SUBJECT: ERRATA FOR AMENDMENT NO. 42, FERMI UNIT 2, FACILITY OPERATING
LICENSE NPF-43 (TAC NOS. 72981 AND 73337)

The changes to the plant Technical Specifications (TS) implemented by License Amendment No. 42 which were transmitted to you by letter dated September 13, 1989, have been found to contain a text error. Also Bases page B 3/4 2-4a should have shown a change in the bounding curves. The enclosed errata TS changes implemented by License Amendment No. 42 are hereby transmitted and should replace the page previously transmitted.

BOC TO 12,700 MWD/ST
MINIMUM CRITICAL POWER RATIO
(MCPR) VERSUS TAU AT RATED FLOW
FIGURE 3.2.3-1

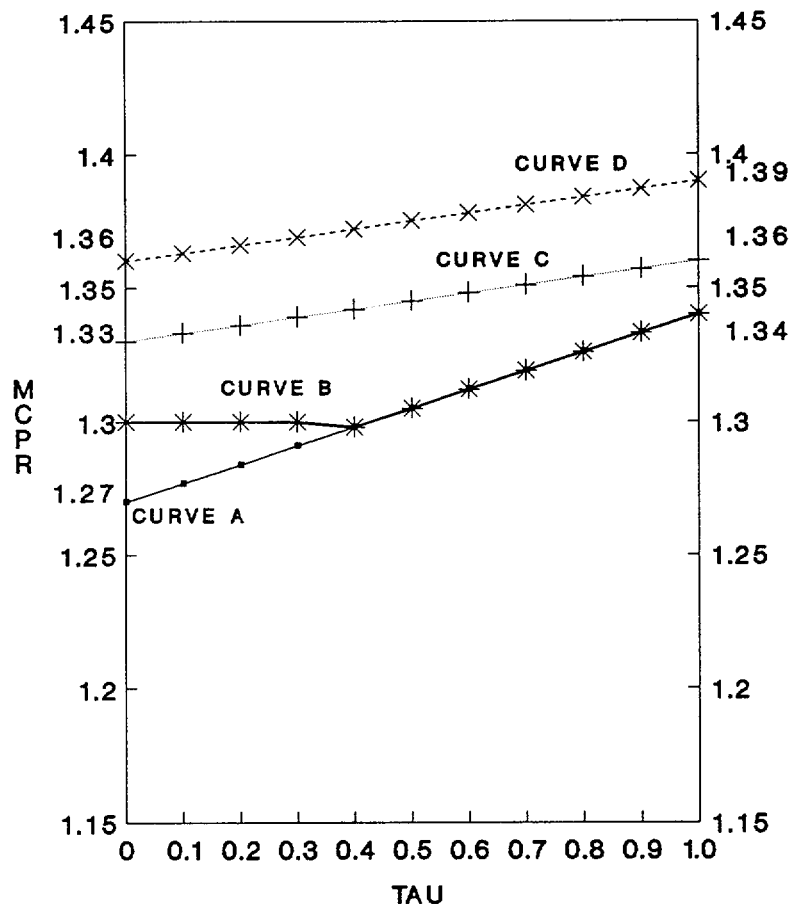
CURVE A - MCPR limit for CCC operational mode with both turbine bypass and moisture separator reheater in service.

CURVE B - MCPR limit for non-CCC operational mode with both turbine bypass and moisture separator reheater in service.

CURVE C - MCPR limit for both CCC or non-CCC operational modes without either turbine bypass or moisture separator reheater.

CURVE D - MCPR limit for both CCC and non-CCC operational modes without both turbine bypass and moisture separator reheater.

FIGURE 3.2.3-1A

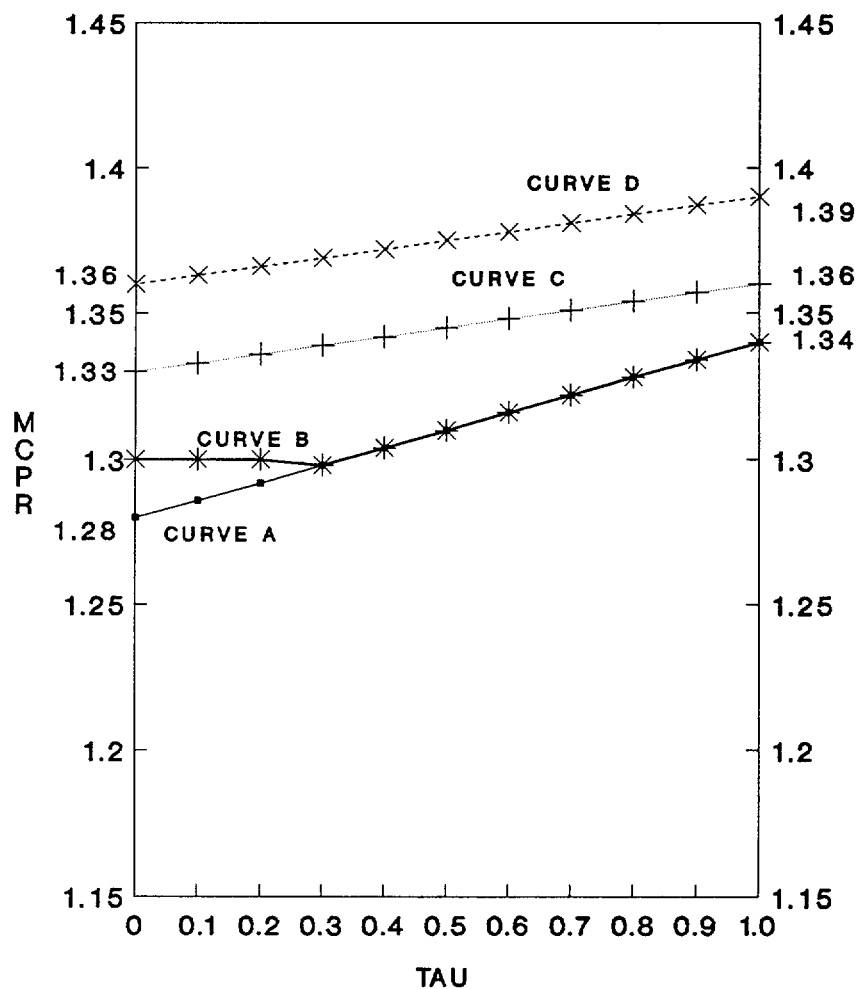
- CURVE A - MCPR limit for CCC operational mode with both turbine bypass and moisture separator reheater in service.
- CURVE B - MCPR limit for non-CCC operational mode with both turbine bypass and moisture separator reheater in service.
- CURVE C - MCPR limit for both CCC or non-CCC operational modes without either turbine bypass or moisture separator reheater.
- CURVE D - MCPR limit for both CCC or non-CCC operational modes without both turbine bypass and moisture separator reheater.
